Access Compliance Report

Public Rights-of-Way

(Curb Ramps)

Intersection ID: 50597	Main Street: DOWNY_BIRCH_RD	Cross Street: GRAY_WILLOW_RD	Location: NW
ADA ID: 0B2BFDD843A0	Ramp Type: Perp	Initial Pass/Fail: Fail	Overall Compliance: No
		Severity Score: 12.5

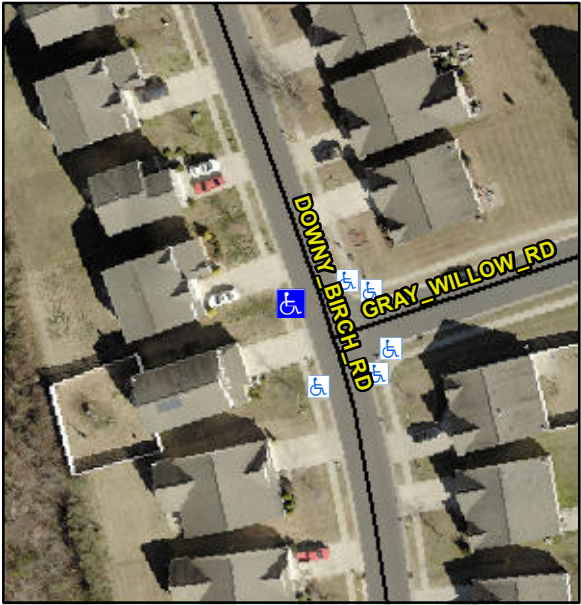
Codes/Mitigation Info/Possible Solution			Field Measurements/Component Compliance		
	Possible Solutions:		Compliance	Description	Data
	Remove & Replace Entire Ramp.		No	Ramp Length (in)	48.0
			Yes	Ramp Width (in)	48.0
			N/A	Flare Type LT	N/A
			N/A	Flare Slope LT (%)	N/A
			N/A	Flare Traversable LT?	N/A
			N/A	Landing Length (in)	N/A
			N/A	Landing Width (in)	N/A
			N/A	Landing Slope (%)	N/A
			N/A	Landing X Slope (%)	N/A
<p>Surveyor Notes:</p> <p>N/A</p> <p>PROW/ADA:</p> <p>Not Found, R304.2.2</p>			N/A	Flare Type RT	N/A
			N/A	Flare Slope RT (%)	N/A
			N/A	Flare Traversable RT?	N/A
			N/A	DWS Provided?	N/A
			N/A	DWS Contrast?	N/A
			N/A	DWS Length (in)	N/A
			N/A	DWS Full Width?	N/A
			N/A	DWS Offset (in)	N/A
			N/A	Shared Landing?	N/A
			N/A	Gutter Ponding?	N/A
			N/A	Gutter Lip Ht (in)	N/A
			N/A	Painted X Walk1?	No
				X Walk 1 Direction	To E
			N/A	X Walk 1 Width (in)	N/A
				X Walk 1 Slope (%)	1.9
				X Walk 1 X Slope (%)	1.0

N/A	Ramp inside XWalk1?	N/A
			N/A	Road Slope (%)	N/A
			N/A	Road X Slope (%)	N/A
			N/A	Any Obstructions?	N/A
				Obstruction Type	
			N/A		
			N/A		
			N/A		
			N/A		
			N/A		
			N/A		
			N/A		
			N/A		
			N/A		
Total Cost:		\$ 1850.00			
			N/A		
			Yes	Surface Condition? (G/P)	Good
